In the Matter of:) Docket No. 09-AFC-1
)
Application for Certification)
For the Watson Cogeneration Steam)
And Electric Reliability Project)

**STAFF COMMENTS ON WATSON COGENERATION
PRESIDING MEMBER’S PROPOSED DECISION**

Staff respectfully submits the following comments on the Presiding Member’s Proposed Decision (PMPD).

VISUAL RESOURCES - FIGURE 1
Watson Cogeneration Steam and Electric Reliability Project - KOP Location

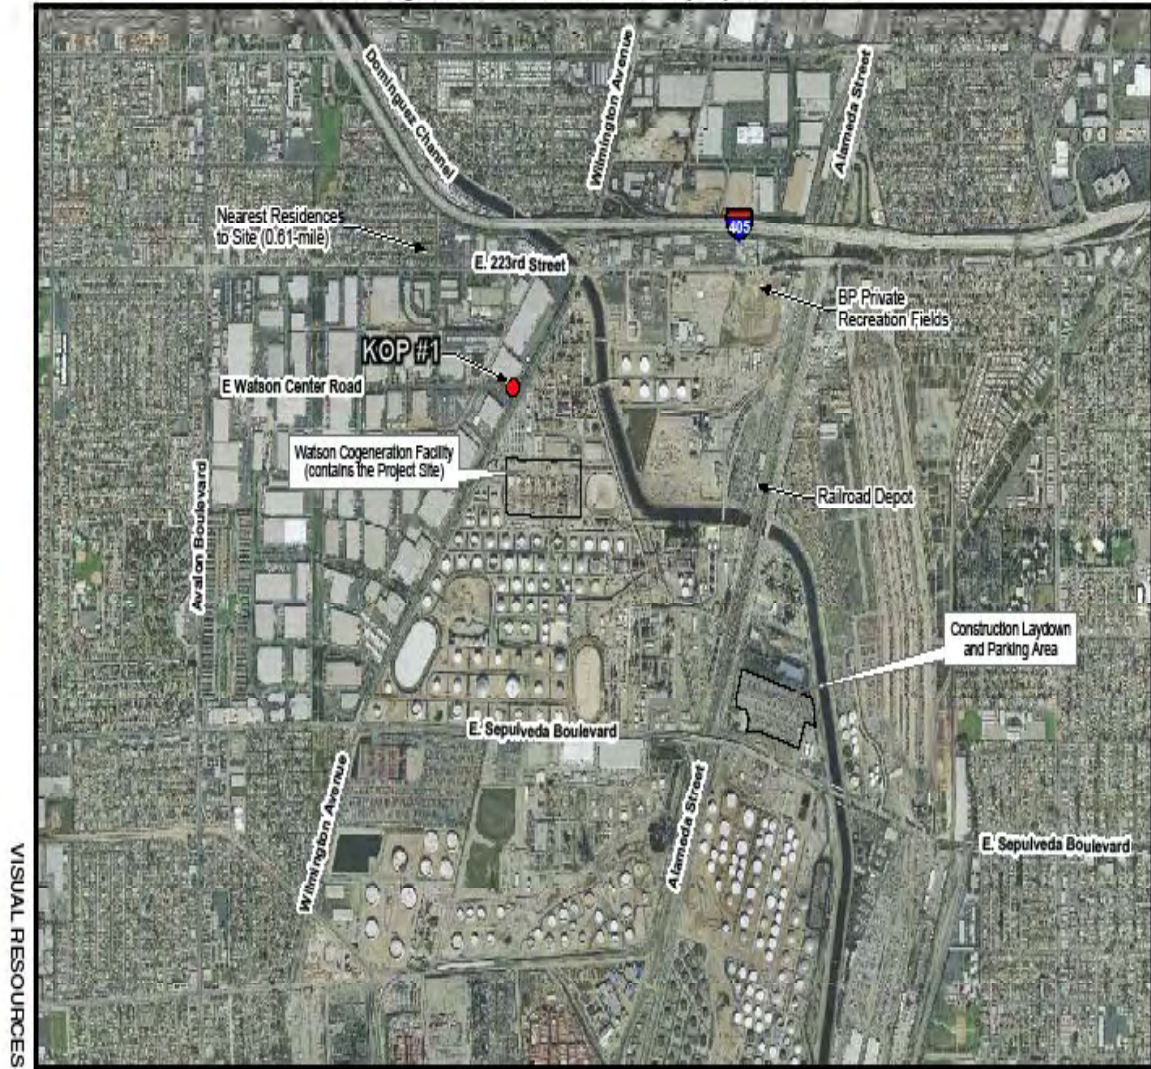
Please replace Visual Resources Figure 1 on page 8.5-4 with the attached revised figure. The arrows and lines in the figure should have been removed from the FSA version as well. This is the corrected version.
